**SUBJECT:** Cessation of Train Whistle – King Street Railway Crossing, Dartmouth

## **INFORMATION REPORT**

Re : Grade Crossing Safety Assessment :  
King St,  
Dartmouth Sub - Mile 12.99

# M.12.99- King St. Sketch

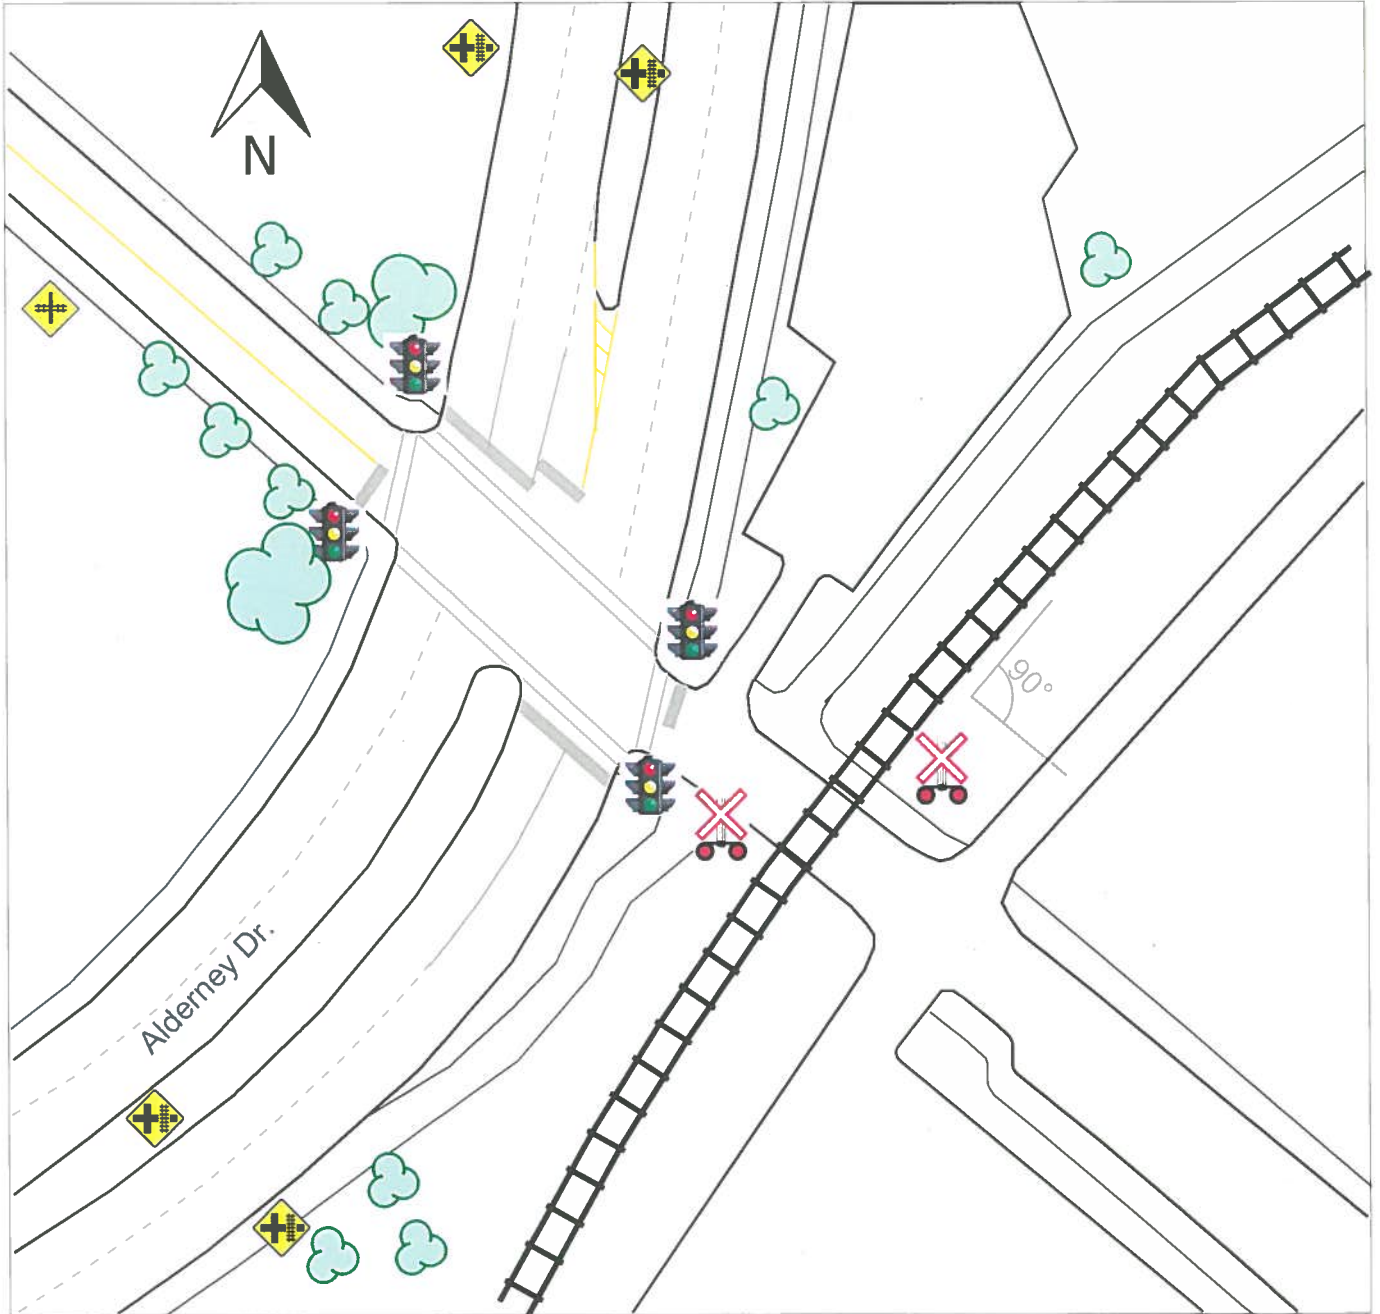
Observations	Suggested Actions	To	Client Response
1 NW quadrant - Crossing sign hidden by lights (see photo 9).	Adjust position of crossing sign and lights	Railway	Comments
2 NW Quadrant - Evidence of routine unauthorized access (trespassing) on the rail line (see photo 11)	Sidewalk is needed as well as fencing to prevent trespassing.	Railway/Road authority	
3 NW Quadrant - Advanced warning sign is not at the appropriate distance from the North side.	Reposition WA-18 sign on King St. 110m from crossing.	Road authority	
4 NW Quadrant – Potential Traffic queuing onto intersecting roadway from crossing	No right turn on red signal needed for right turn from Alderney Drive to King Street towards crossing.	Road authority	
5 NW/NE Quadrant - crossing sign obscured by trees (see photo 8)	Trim or remove trees to improve visibility of crossing signs	Road authority	
6 NE Quadrant – Sidewalk not protected by gates and lights	Pedestrian gates and lights are needed for sidewalk on the NE side of crossing.	Railway

7 SE Quadrant - Advanced warning sign is not at the appropriate distance from the crossing.	Add WA-18 signs on King St. 110m from crossing.	Road authority	
8 SE Quadrant - Pavement markings are missing.	All required pavement markings should be applied: “X” marking, “No Passing” lines, and “Stop” bars.	Road authority	
9 SE Quadrant -- Traffic queuing onto crossing from intersection	Do not stop on track sign needed for South approach.	Road authority

10	SW Quadrant – partial sidewalk/pathway not protected by gates and lights.	Pedestrian gates and lights are needed. Sidewalk should be completed on the SW side of crossing.	Road authority		
11	Crossing surface – Elevation of top rail is 40mm below crossing surface.	Crossing surface should be adjusted to be less than 25mm above the top of rail.	Railway/Road authority		
12	Gate descent time was measured at 7 seconds and gate arm delay was measured at 6 seconds	Gate descent time should be adjusted to be within 10 to 15 seconds and gate arm delay should be adjusted to 7 seconds.	Railway		
13	Parking lots on both sides of the road in the south approach to the crossing do not have light unit coverage (see photos 12 and 13)	Additional light units are required for drivers as they begin to turn onto the approach road from the two parking lots.	Railway/Road authority

Requirement (received Feb 28 <sup>15</sup> from Hatch Mott and Macdonald).	Suggested Action	Responsibility	Status/Next Steps
1. NW quadrant – Crossing Sign hidden by lights.	Adjust position of crossing sign and lights	CN Rail	CN to adjust / relocate sign.

2. NW Quadrant – Evidence of routine unauthorized access (trespassing) on the rail line	Sidewalk is needed as well as fencing to prevent trespassing	CN Rail / Kings Wharf	Dexter Construction to complete as part of original contract.

3. NW Quadrant- Advanced warning sign is not at the appropriate distance from the North Side.	Reposition WA-18 sign on King St. 110m from crossing	HRM	Signage location was reviewed and determined that current placement is appropriate. CN agreed.

4. NW Quadrant – Potential Traffic queuing onto intersecting roadway from crossing.	No right turn on red sign needed for right turn from Alderney Drive to King Street towards crossing.	HRM	HRM is currently in discussions with Transport Canada to determine appropriate operation of traffic signal / grade crossing warning system interconnect as per the Grade Crossing Standards. This item is still outstanding, but is in progress.

5. NW/NE Quadrant – crossing sign obscured by trees.	Trim or remove trees to improve visibility of crossing signs.	HRM	HRM Urban Forestry was tasked with evaluating the situation and trim trees as appropriate.

6. NE Quadrant – Sidewalk not protected by gates and lights.	Pedestrian gates and lights are needed for sidewalk on the NE side of crossing.	CN Rail	CN Rail has determined this to be unnecessary.

7. SE Quadrant – Advanced warning sign is not at the appropriate distance from the crossing.	Add WA-18 signs on King's Wharf Place 110m from the crossing.	HRM	An appropriate location has been identified for this roadway approach and signage will be installed. CN in agreement.

8. SE Quadrant – Pavement markings are missing.	All required pavement markings should be applied 'X' marking. "No Passing" lines and stop bars.	HRM	HRM to install double stop bars at the grade crossing. "X" markings are not required. CN is in agreement with this approach.

9. SE Quadrant – Traffic queuing onto crossing from intersection.	Do not stop on track sign needed for South approach.	HRM	HRM to install "Do not stop on track" sign, but cross-hatching will not be required.

10. SW Quadrant – partial sidewalk/pathway not protected by gates and lights.	Pedestrian gates and lights are needed. Sidewalk should be completed on the side of crossing.	HRM	CN Rail has determined this to be unnecessary.

11. Crossing surface – Elevation of top rail is 40mm below crossing surface	Crossing surface should be adjusted to be less than 25mm above the top of rail.	CN Rail / HRM	Crossing surface to be reviewed at next scheduled maintenance and rehab date. Not required to request whistle cessation.

12.	Gate descent time was measured at 7 seconds and gate arm delay was measured at 6 seconds.	Gate decent time should be adjusted to be within 10 to 15 seconds and gate arm delay should be adjusted to 7 seconds.	CN Rail	CN has indicated that the equipment at the location is working properly and is in compliance with requirements.

13.	Parking lots on both sides of the road in the south approach to the crossing do not have light unit coverage	Additional light unit are required for drivers as they begin to turn onto the approach road from the two parking lots.	CN Rail / Kings Wharf	CN has determined that additional lights are required. They have provided a cost to have the lights supplied / installed and are requesting payment before scheduling the work.

14.	Access to Parking Garage during train crossing may be blocked causing queuing on tracks. (added by CN Rail)	Requires "hatching: in front of access to parking garage to prevent cars from blocking entry.	HRM	HRM will install additional signage related to blocking of the driveway as well as additional "Do not stop on tracks" signage. Painted hatching will not required.
